Michael A. Berardi
Director
Service Engineering Operations
Ford Customer Service Division

TO: All U.S. Ford and Lincoln Mercury Dealers

SUBJECT: Safety Recall 09S09
Certain 1992-2003 Model Year Vehicle Lines
Speed Control System Modification

FIGURE 1

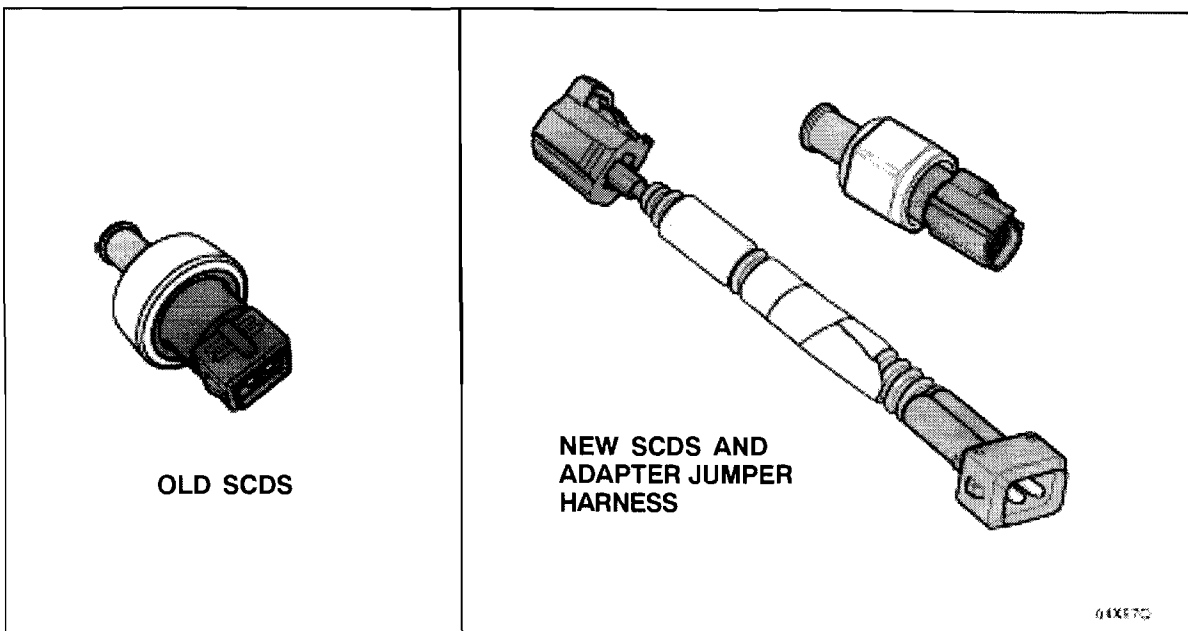
The Speed Control Deactivation Switch (SCDS) involved in Safety Recall 09S09 and the revised SCDS are illustrated below (See Figure 1).

Note that the revised SCDS has a different electrical connector. An adapter jumper harness (which is included in the parts kit) is required when replacing the old SCDS with the revised SCDS.
